Memorandum

Subject: **Review of Newark Bay Study Area Screening Level Ecological Risk Assessment (SLERA)**

This report presents Gradient's review of the Screening Level Ecological Risk Assessment (SLERA) for Newark Bay, prepared by Malcolm Pirnie and Battelle, on behalf of the United States Environmental Protection Agency (US EPA) (Malcolm Pirnie, 2008). The SLERA divides Newark Bay into three sections ("Reaches"): Northern, Middle, and Southern. The report concludes that:

FIGURE 1

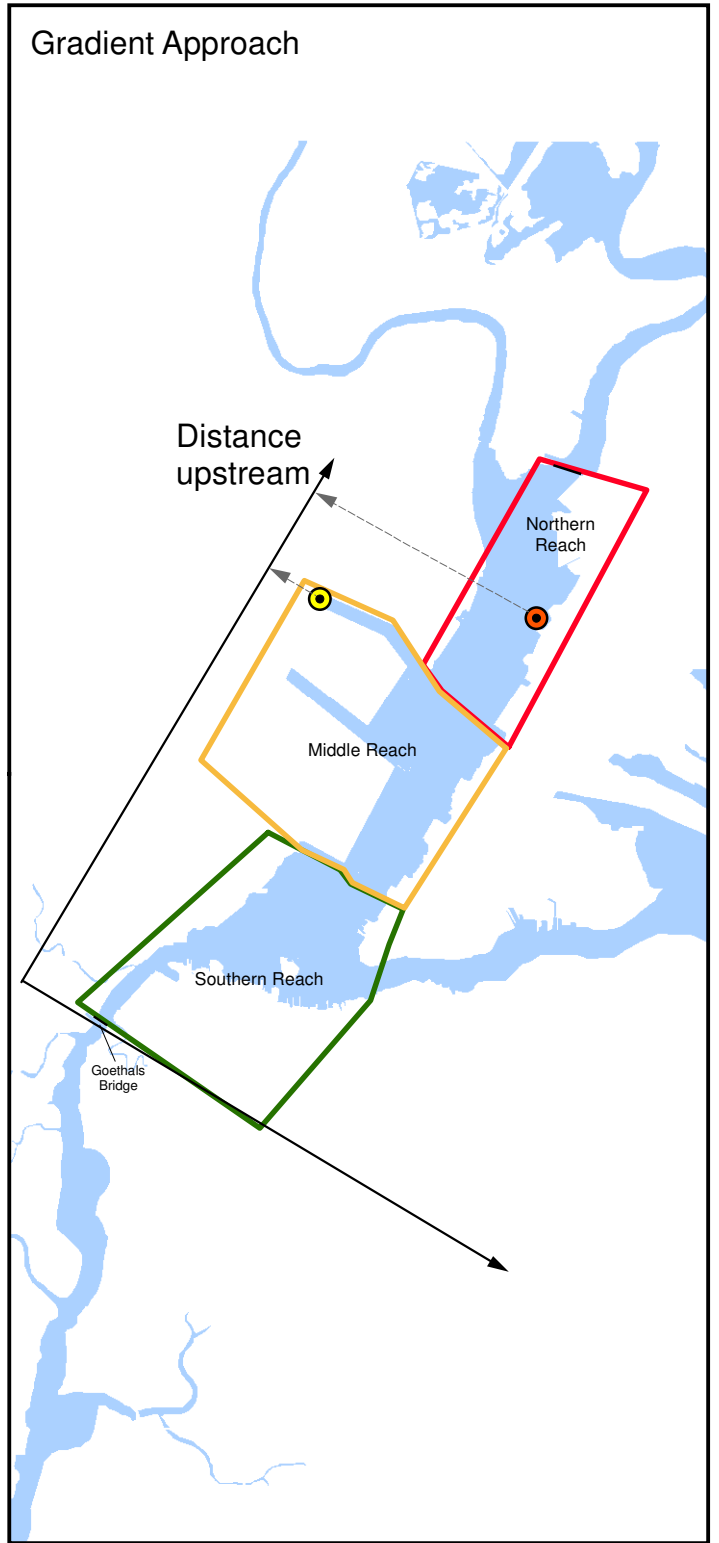
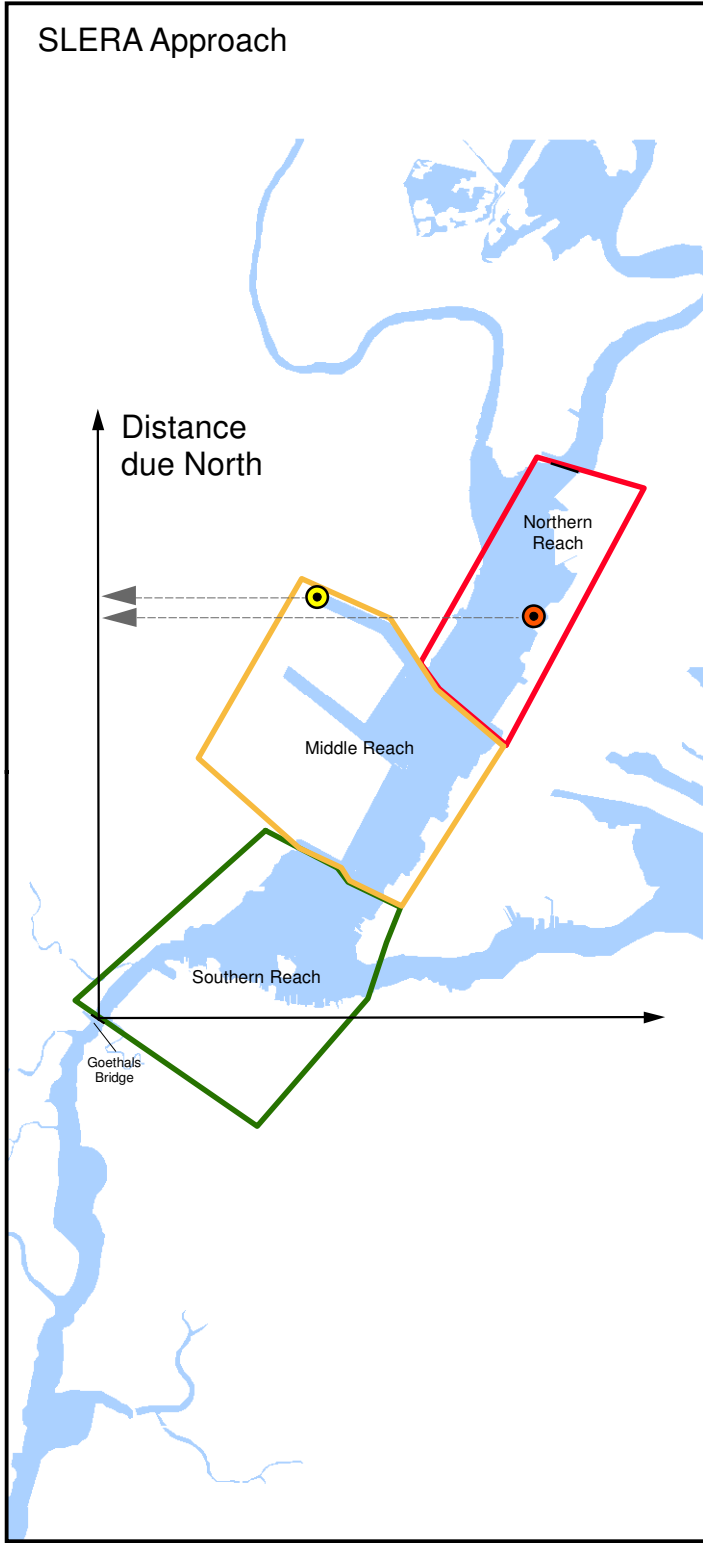
1 An inappropriate coordinate system was used to analyze contaminant distribution and sources.

The SLERA uses an inappropriate coordinate system, which has led to assignment of sampling locations to incorrect "Reaches" within Newark Bay and generation of inaccurate concentration-distance plots. The coordinate system used in the SLERA measures distance along an arbitrary north-south axis rather than along the axis of flow within the Bay (Figure 1). This seemingly small difference in axis orientation has a significant effect on data interpretation (Figure 1). For example, as illustrated in Figure 1, samples collected from Port Newark Channel and portions of the Northern Reach appear at the same location in the concentration-distance plots presented in the SLERA (Figures 8-15 of the SLERA). Consequently, concentrations measured in samples collected in the Northern Reach are being interpreted

as having been collected in the Middle Reach and/or Port Newark Channel. This problem with the coordinate system appears to have led to assigning sampling location NB901 (discussed below) to the Middle Reach in the SLERA. We recommend that the coordinate system misalignment be rectified and the assignment of samples to Newark Bay Reaches be reviewed by US EPA, prior to commencement of the BERA.

**FIGURE
2**

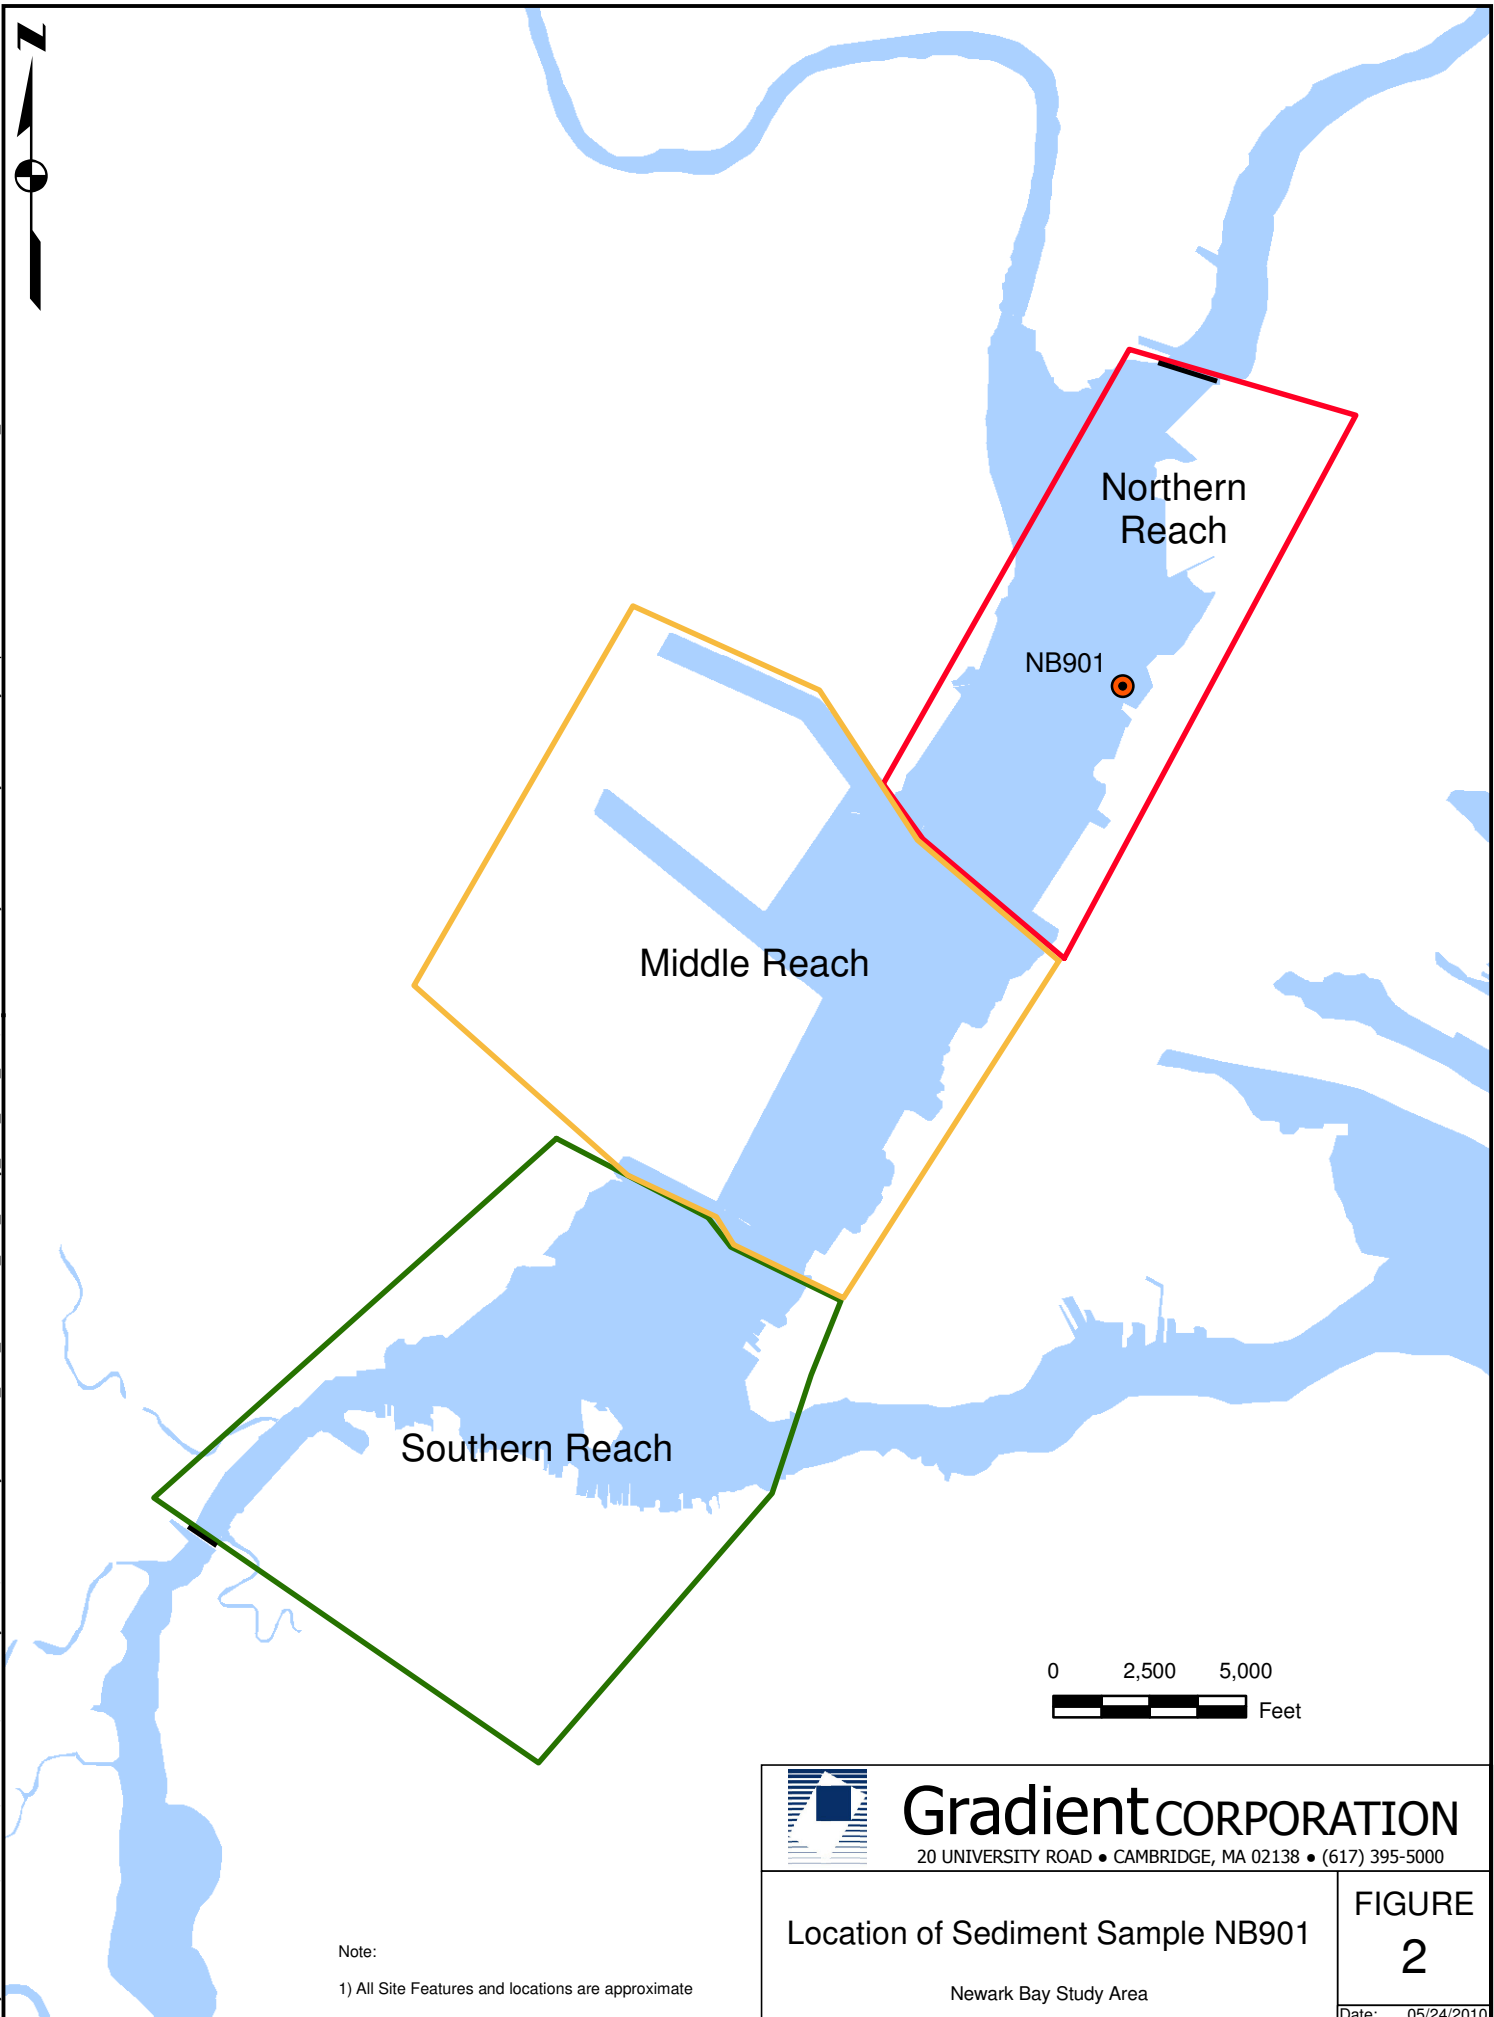
2 A key Northern Reach data point (NB901) was incorrectly included in the Middle Reach.

Due to the misaligned coordinate system, a key sediment sample in Newark Bay (NB901), located in the Northern Reach, was incorrectly used to assess ecological risks for the Middle Reach (Figure 2). Sample location NB901 is important because it contained high sediment concentrations of several compounds, including the highest surficial mercury concentration recorded in the Northern Reach (10,700 µg/kg). This sample also contained high concentrations of arsenic (26,100 µg/kg), copper (234,000 µg/kg), total DDx (730 µg/kg), and 2,3,7,8-TCDD (0.26 µg/kg). Since NB901 is located within the depositional area of the Passaic River, this sample is a good representation of sediments contributed to Newark Bay from the Passaic River.
